RE: RFI RESPONSE – AREA 13-15 ST LEONARDS SOUTH (DA 56/2023)

This letter relates to DA56/2023 (**the DA**) which seeks development consent for construction of a residential development comprising three residential flat buildings with basement car parking and associated landscaping and creation of new pedestrian landscaped link (**the proposal**) at 14-16 Marshall Avenue, 5-9 Holdsworth Avenue & 2-10 Berry Road, St Leonards (**the site, Area 13-15 St Leonards South**). The development application was lodged to the Lane Cove Council (**the Council**) in May 2023.

Table 1 Response to RFI matters in Council's letter dated 18 August 2023

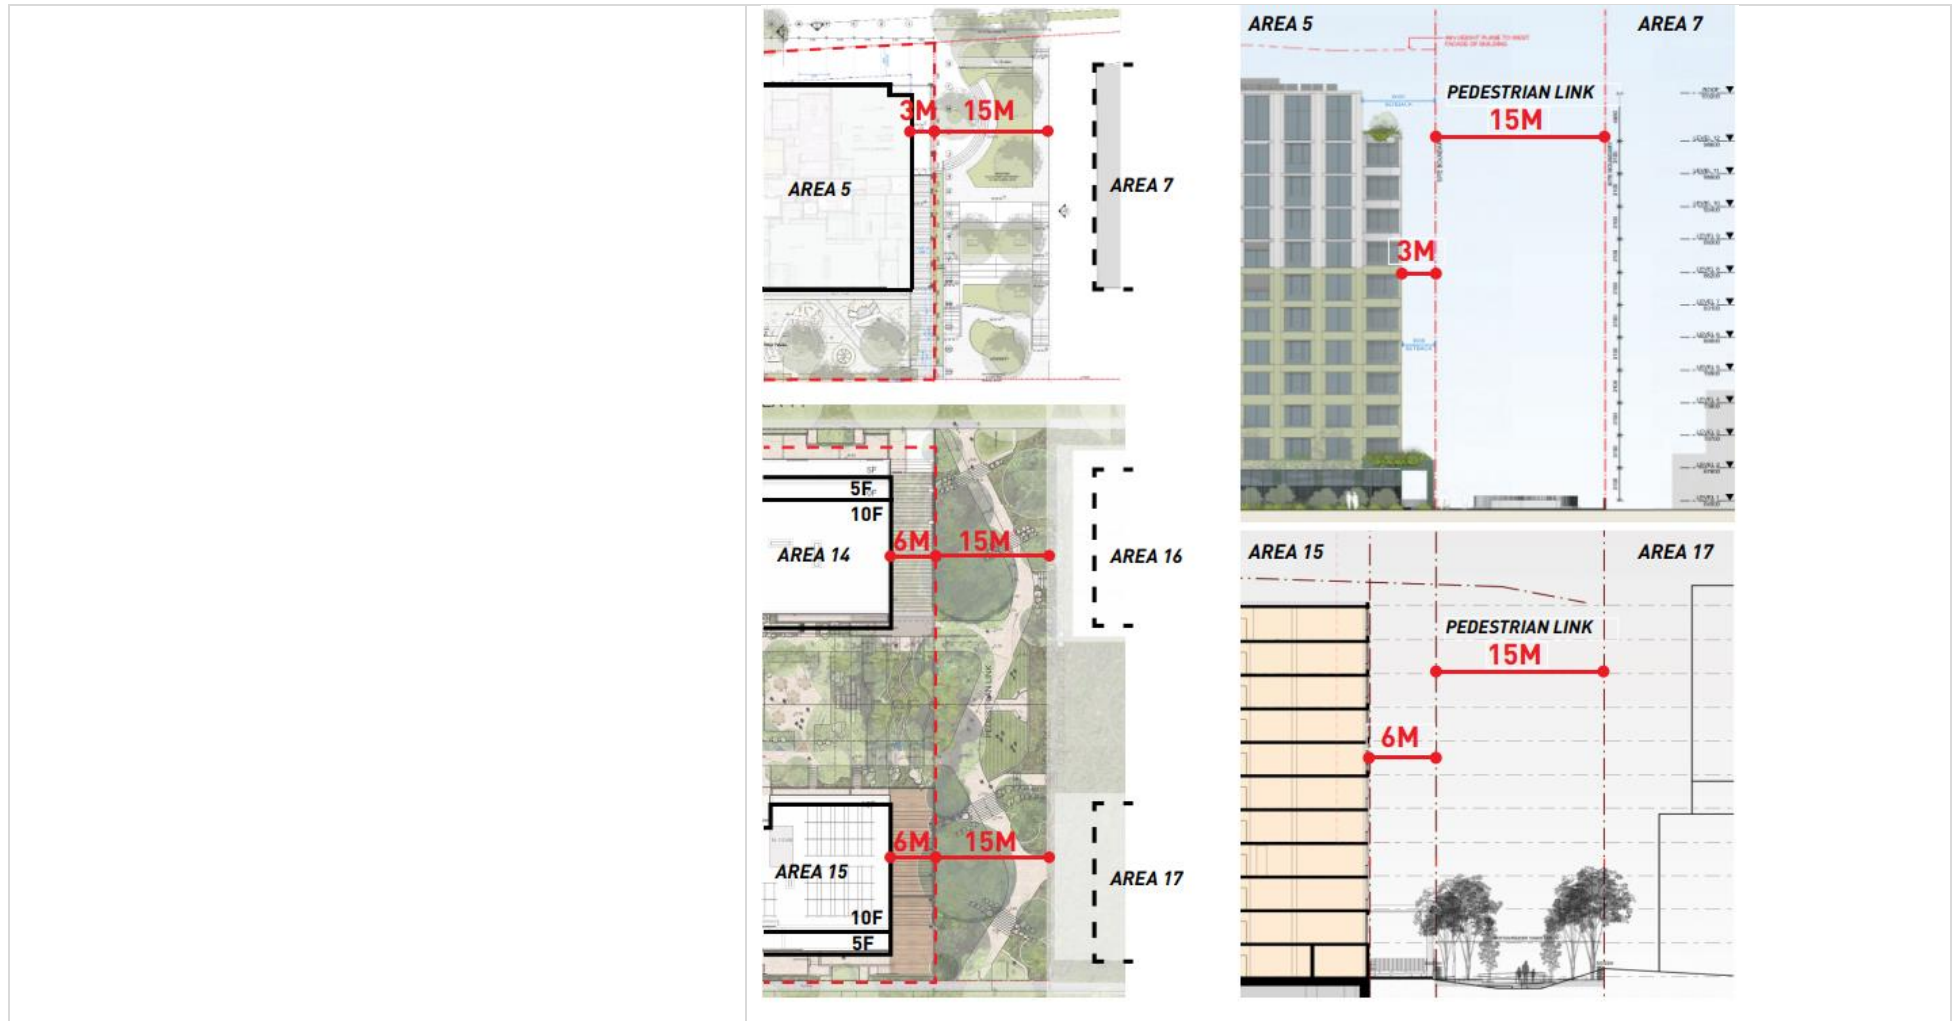
Council Comment	Applicant Comment
	<p data-bbox="947 435 2051 499">considered to warrant a different approach top other sites along the east-west pedestrian link , and that didn't occur.</p> <ul data-bbox="902 531 2063 882" style="list-style-type: none"><li data-bbox="902 531 2063 715">▪ Our proposal has a greater level of setback compliance compared with Areas 5. The Area 5 building was approved with a significantly less setback at all levels, in contrast to the proposed development at the subject site where the non-compliance is only from level 5 and above, and the non-compliance would just be 3m. As shown in the figure below, the proposal offers a significantly greater separation distance from the pedestrian link compared to Area 5.<li data-bbox="902 738 2063 882">▪ Although this development must be considered on its own merits, given there is precedent in the precinct that have already been approved with reduced setbacks, it cannot be asserted that this particular control has been strictly applied and thus the consideration of an alternate approach to meet the objectives of the provision is a relevant proposition to be assessed.
